CWL12 DATA CENTRE S73 APPLICATION

Document title: Planning Statement

Client	Vantage Data Centers
Project	CWL12 Data Centre S73 Application
Job number	100096692
Client signature/date

Figure 3-1 – Extent of Proposed Cladding Colour Change

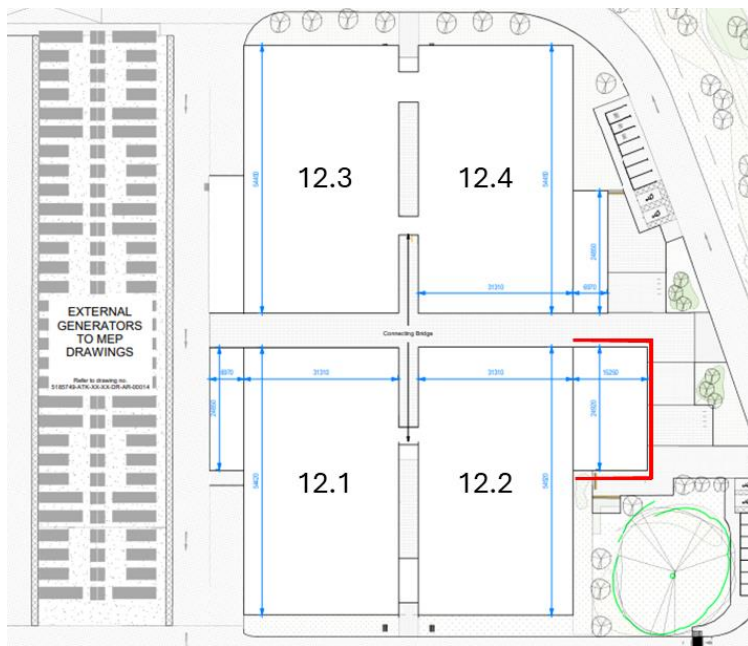
The elevation drawings submitted with this application illustrate the proposed change of cladding panel colour to the ground floor level on the entrance section to building 12.2 from light grey to Ephyra, as indicated in red in Figure 3-1 and Figure 3-2. The proposed change affects the ground floor level of the principal façade, accommodating the main entrance and reception area to the CWL12 Data Centre.

Figure 3-3 - Consented Access Arrangement (left) and Proposed Access Arrangement (right)

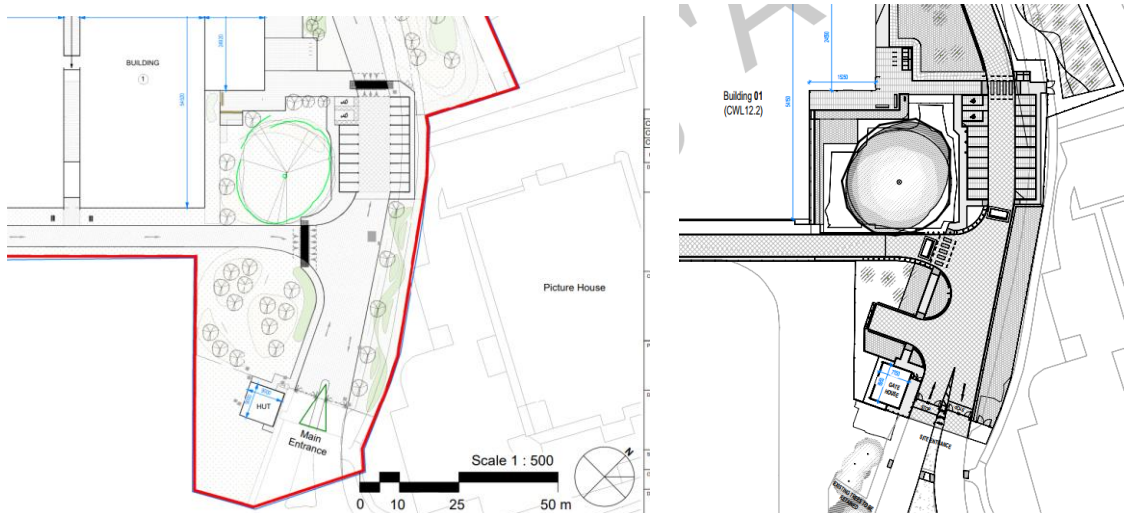
The security kiosk will be repositioned further into the site entrance to avoid development on locally adopted highway land. The dimensions of the security kiosk have reduced during the detailed design stage; from the consented dimensions of 9m by 8.955m and a height of 4.2m to proposed dimensions of 7.15m by 8.95m and a height of 3.7m.

A vehicle rejection bay is proposed, in the form of a turning head. The turning head is required and designed to accommodate safe turning manoeuvres for HGVs that are refused entry to the site, in accordance with security protocols. Two hydraulic ramp barriers will be installed within the site to create a vehicle airlock capable of contain rejected vehicles. The arrangement consented under the existing permission, as shown in Figure 3-3 - Consented Access Arrangement, does not make provision for on-site turning of rejected vehicles, meaning rejected vehicles would need to reverse onto the public highway. The proposal is necessary for the site to operate and will represent an improvement for highway safety.

To accommodate the vehicle rejection bay, it is necessary to remove the rain garden previously located adjacent to the security kiosk. Additional drainage has been added north of the security kiosk to compensate for this loss. This proposed change will ensure that the SAB approval is still valid for the site drainage.
